ADDENDUM NO. 1**SPRING 2025 LANDFILL GAS COLLECTION SYSTEM EXPANSION REBID
RFB #26-004****SOUTH WAKE LANDFILL
APEX, NORTH CAROLINA**

February 5, 2026

Prospective Bidders are hereby advised of the following revisions to the Bid Documents for the subject Project:

RESPONSE TO BIDDERS' QUESTIONS NO. 1**SPRING 2025 LANDFILL GAS SYSTEM EXPANSION RE-BID
RFB #26-004****SOUTH WAKE LANDFILL
APEX, NORTH CAROLINA**

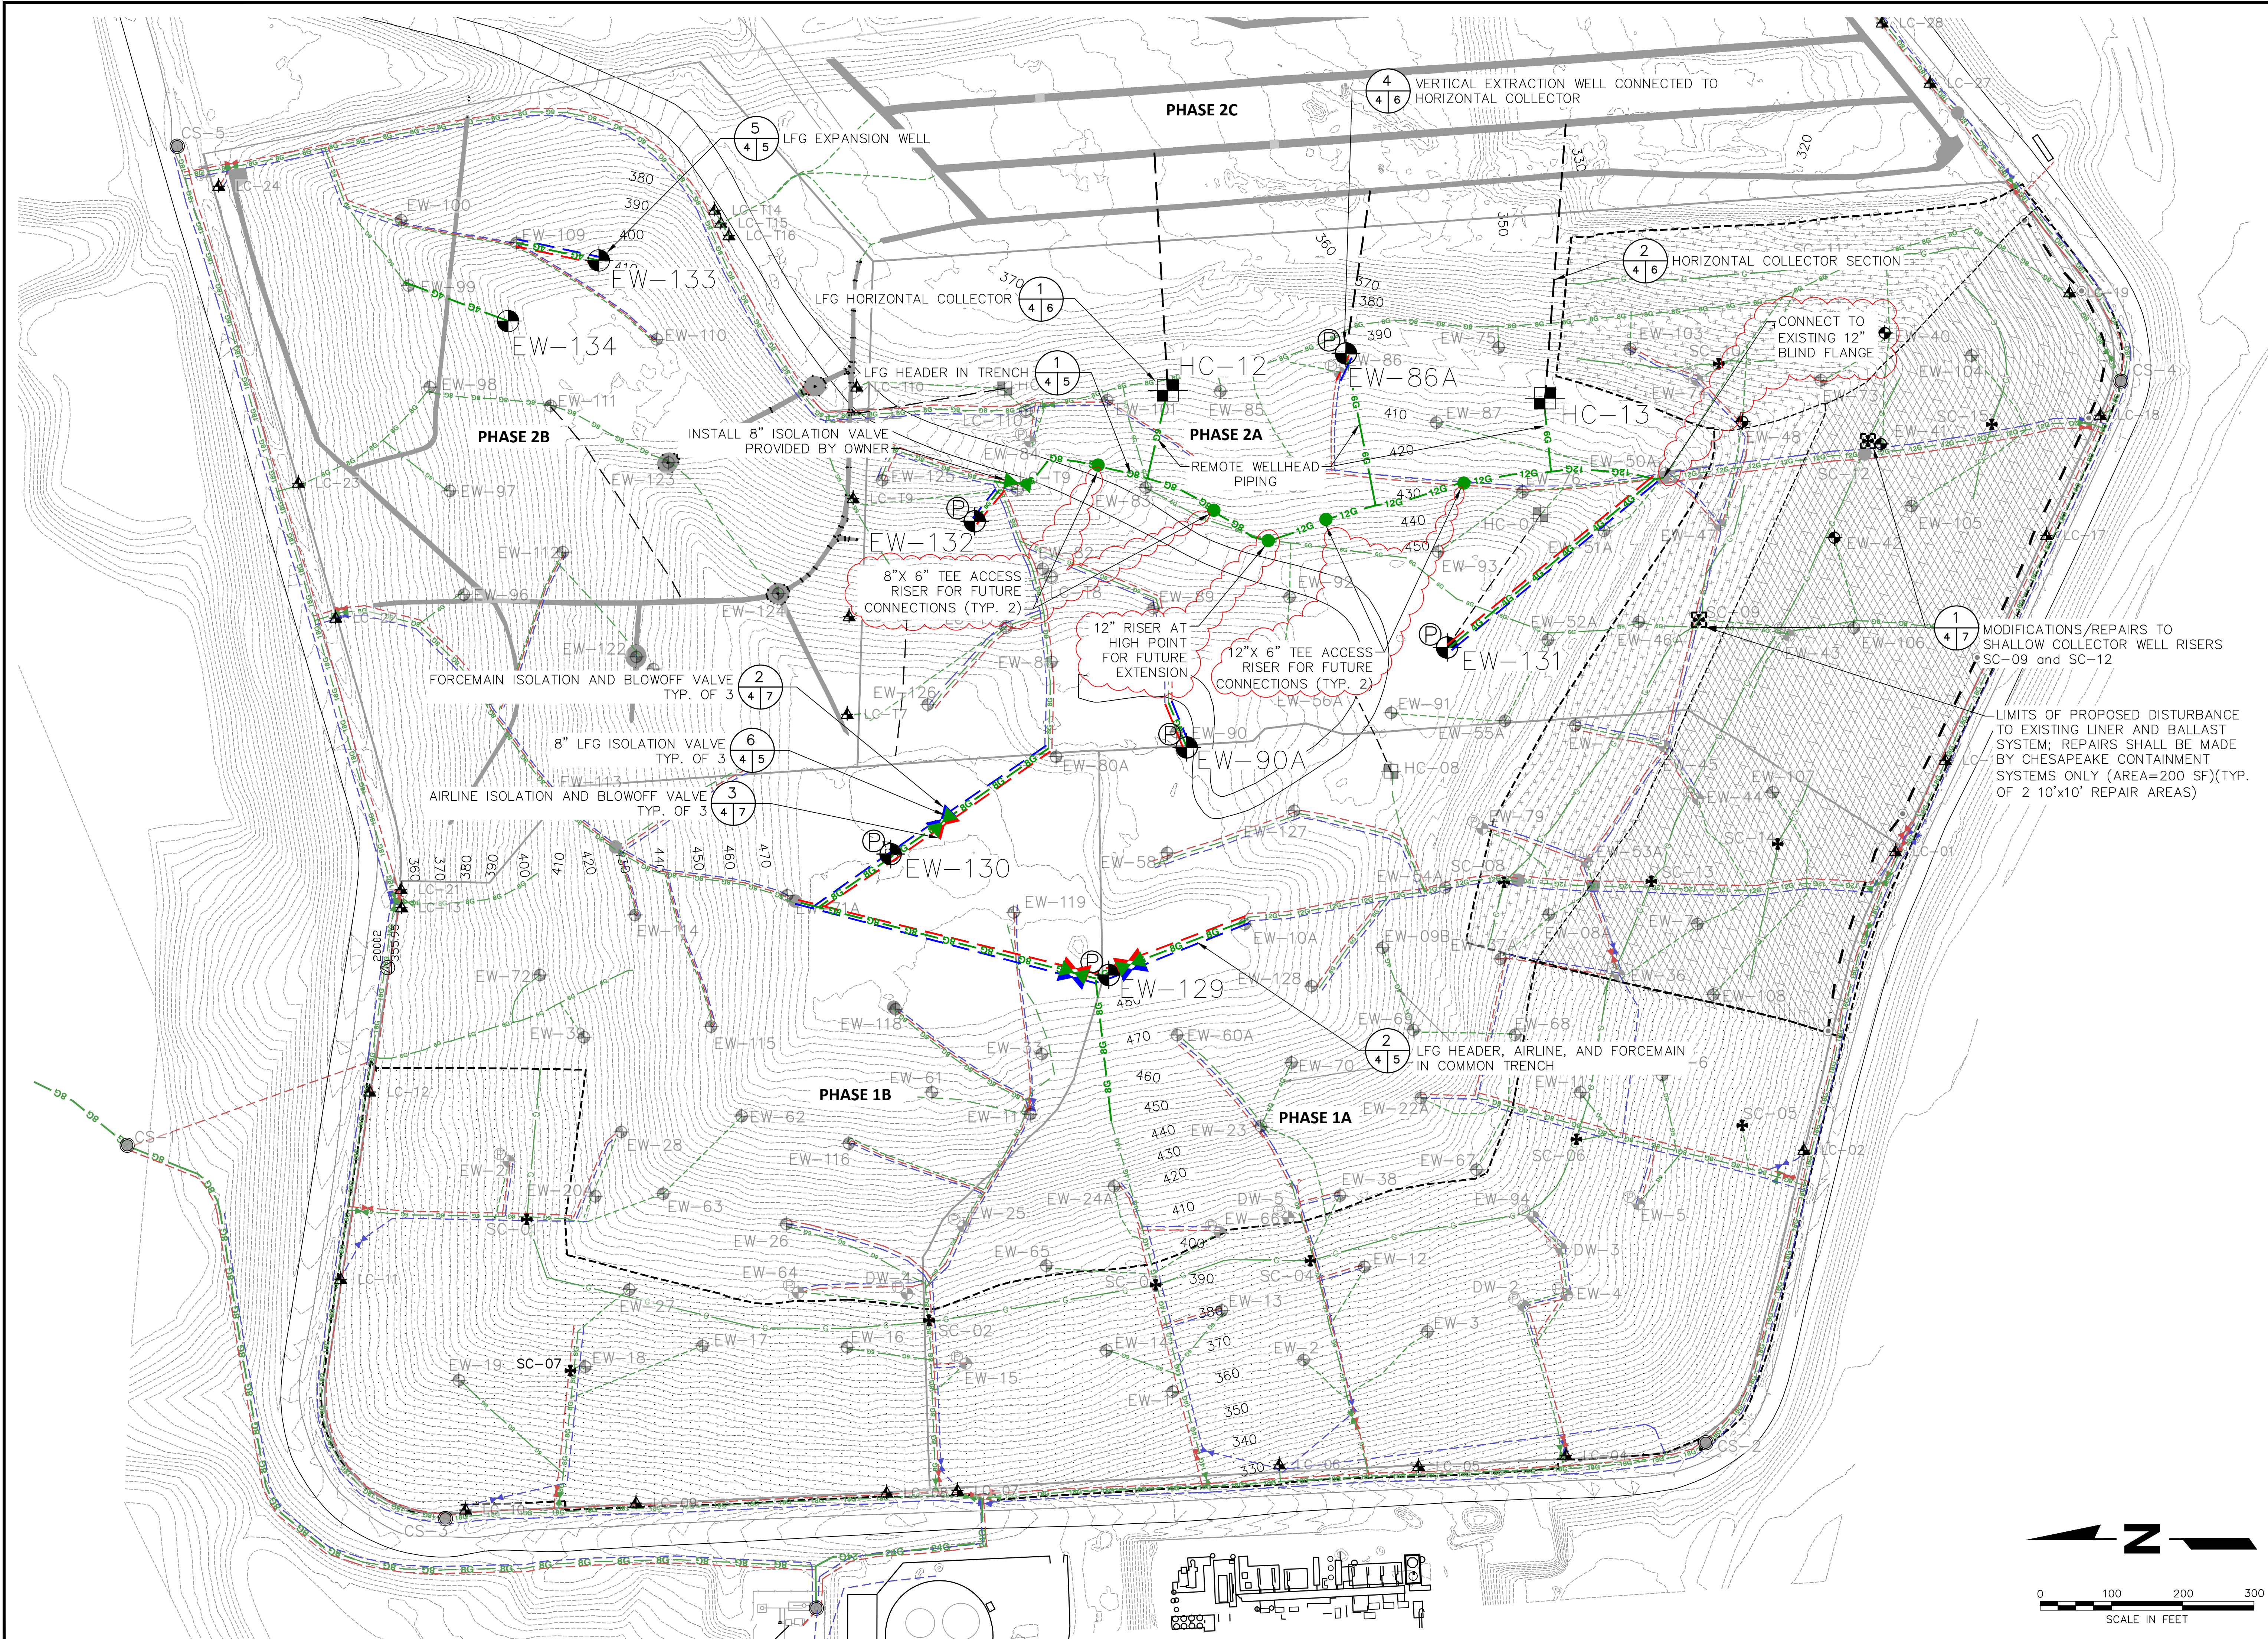
1. **Attachment 1:** The Plans (revision 1) have been modified to revise callouts, add an additional 12" stub-up, and increase text size on 6" proposed piping.
2. **Attachment 2:** The Project Manual (revision 1) has been modified to include the 12"x6" risers and 12" stub-up in the Bid Form.
3. **Attachment 3:** Response to Bidder Questions.
4. **Attachment 4:** Preferred seeding mix for revegetation

VERTICAL EXTRACTION WELL CONNECTED TO HORIZONTAL COLLECTOR (VERTICAL-HORIZONTAL) WITH DRAINAGE PIT DETAIL
NOT TO SCALE

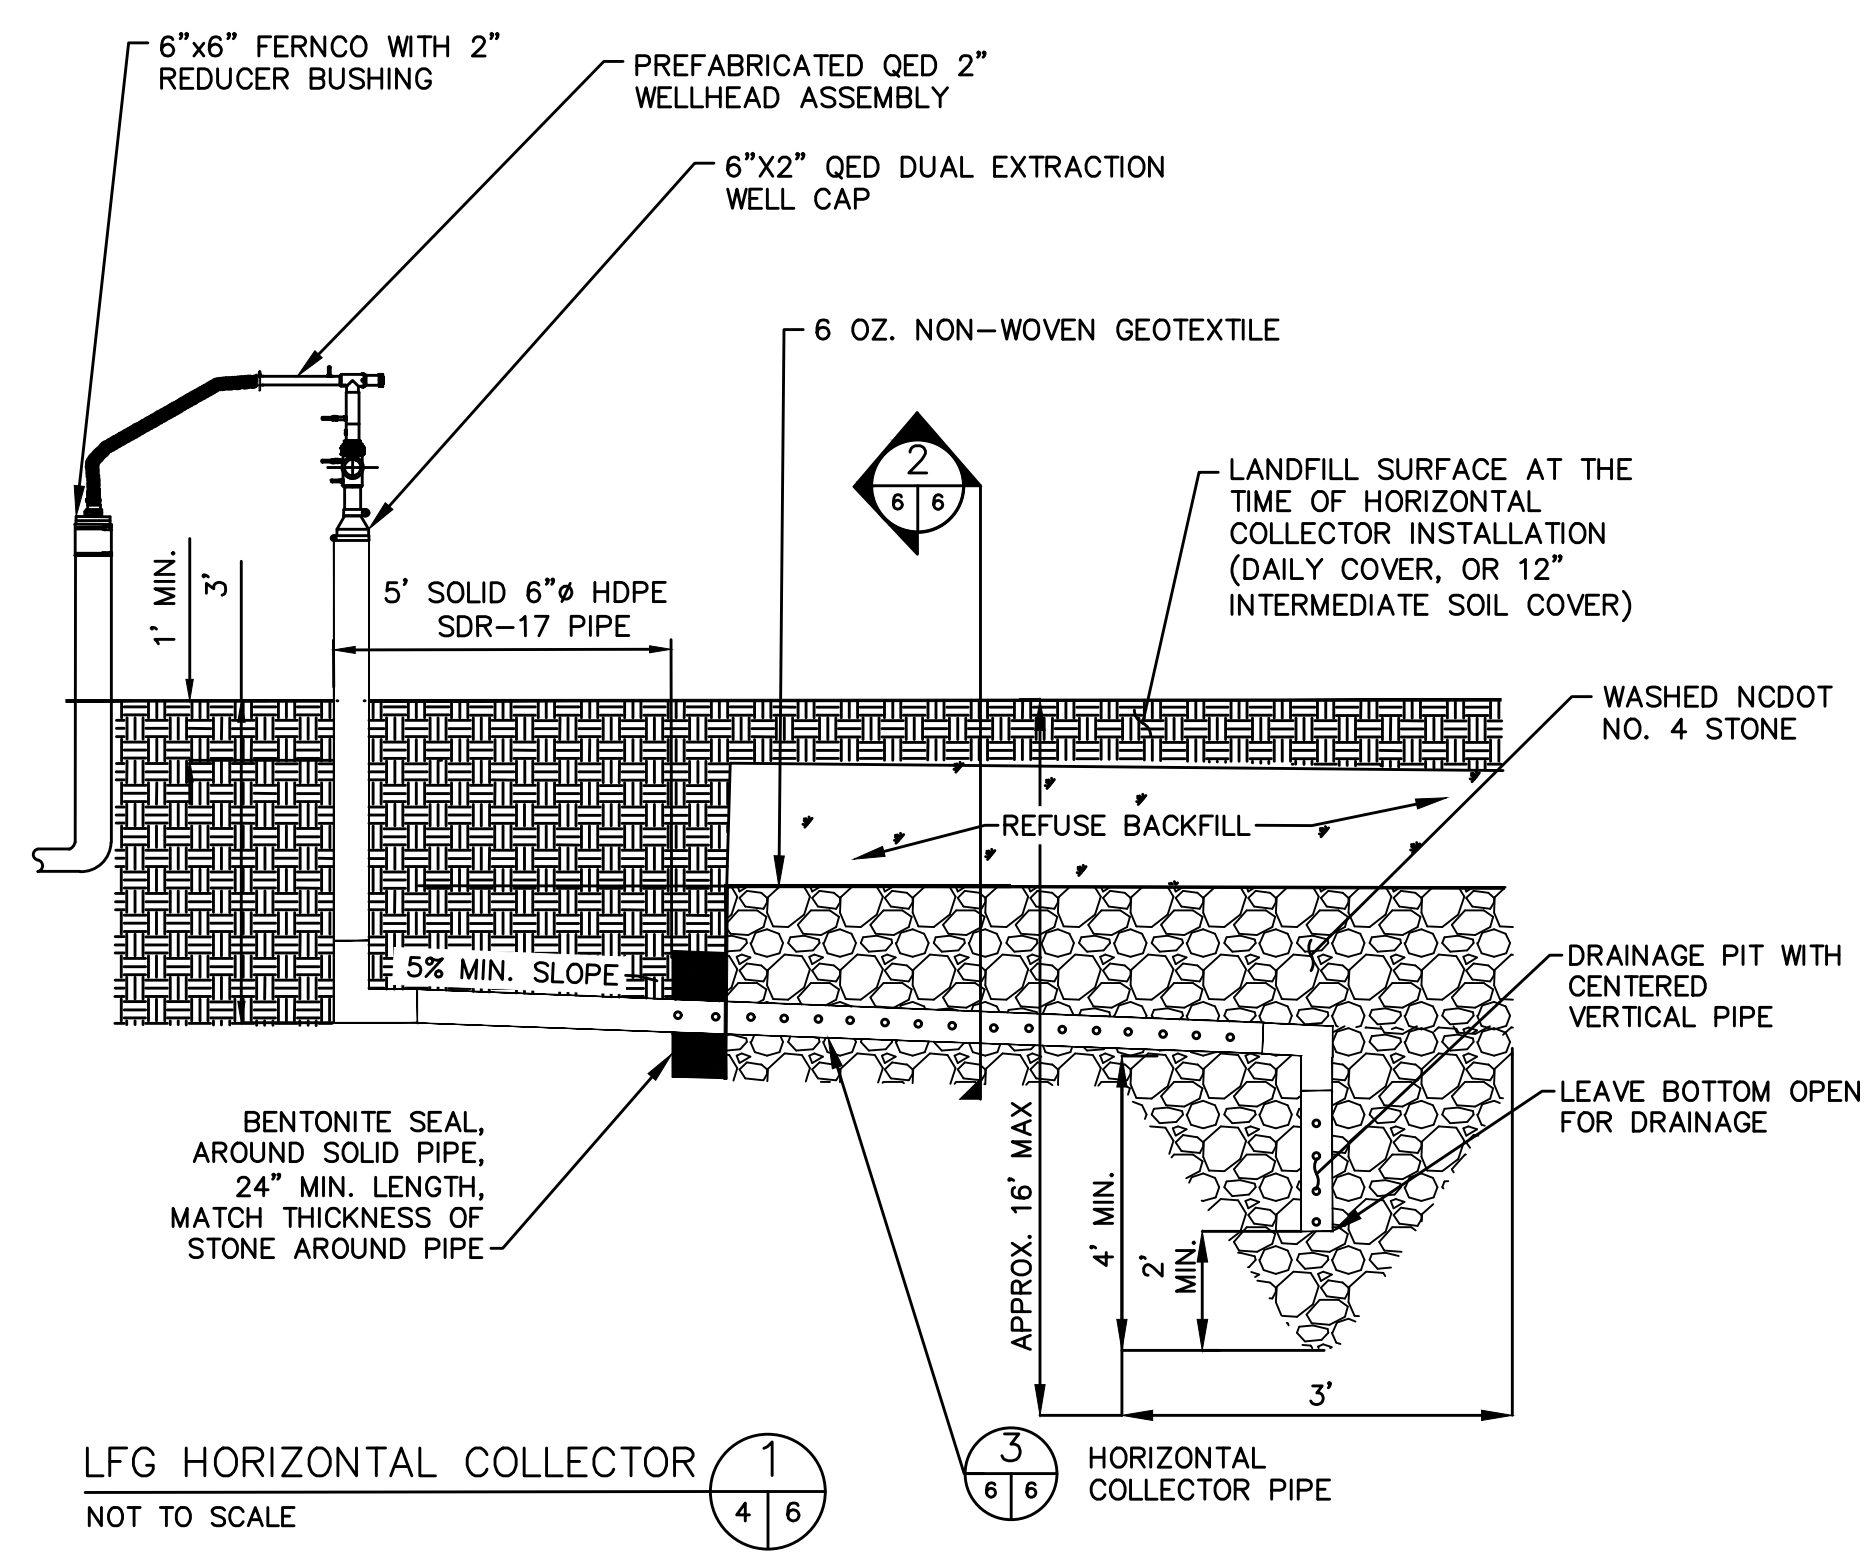
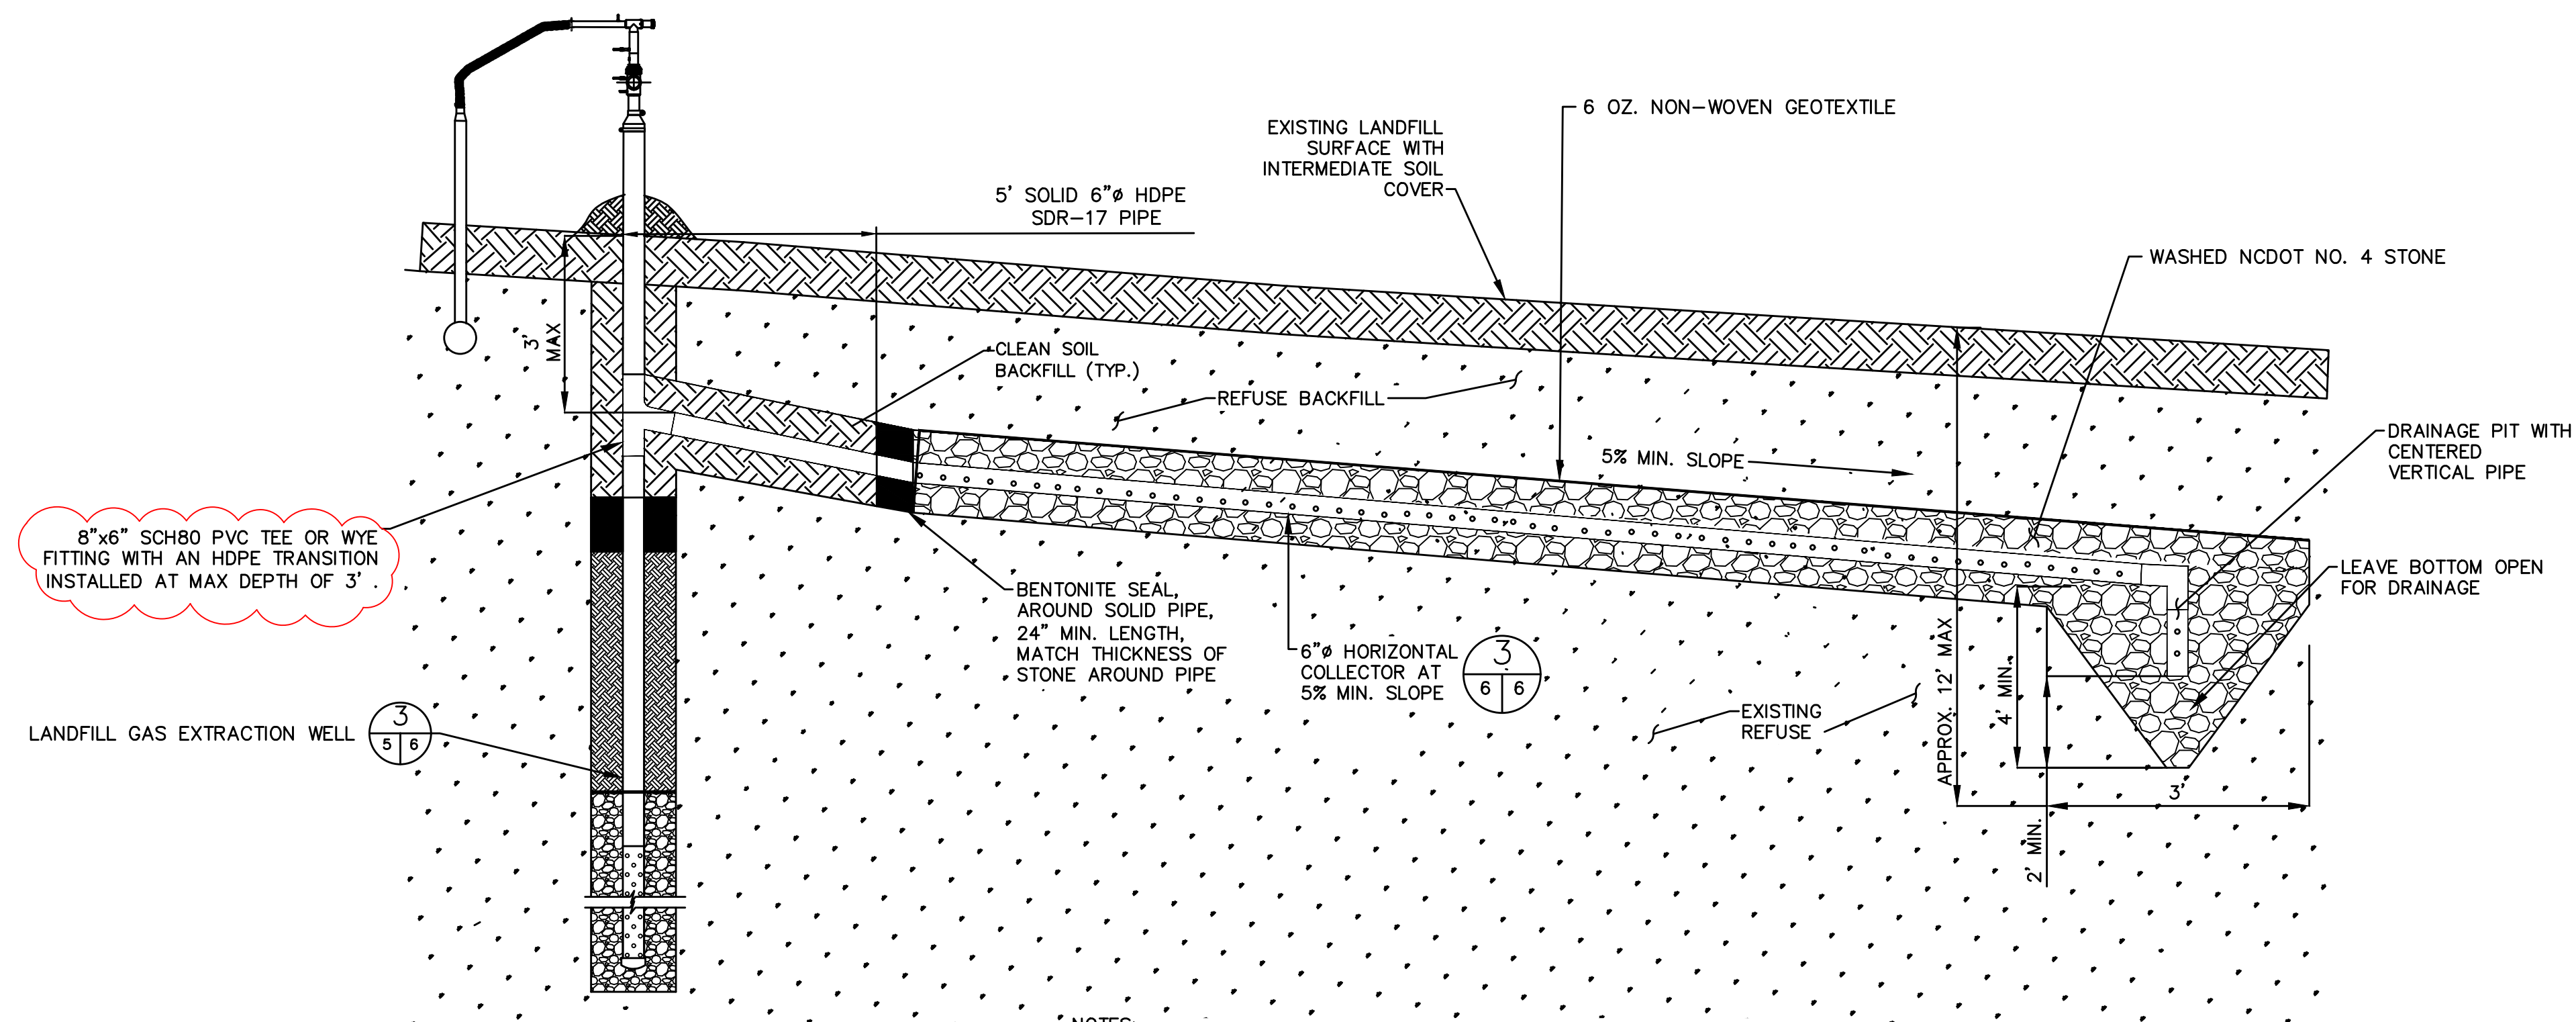
4. In the drawing set – Drawing No. 6 Detail 4 – shows an 8” x 6” HDPE tee being fused into an 8” SCH80 PVC well. Can it be confirmed what the actual procedure for this shall be – possibly a SCH80 tee with a flanged connection to the horizontal collector?

Yes, the Tee should be SCH80 PVC; this is revised revision 1 of the Plans included in Addendum 1. A flanged connection is acceptable for a PVC/HDPE transition.

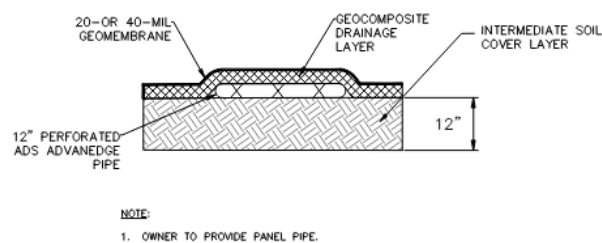
26. Can a cross section of the final cover trench be provided?

Assuming this refers to the 12" flat panel pipe in the EGC area, see cross section below.

As shown in the response to Question 26, typical intermediate cover soil is acceptable backfill in and around the shallow collector repairs, but the Contractor must remove any incidental rocks, roots, or other materials that could harm the liner when placing.
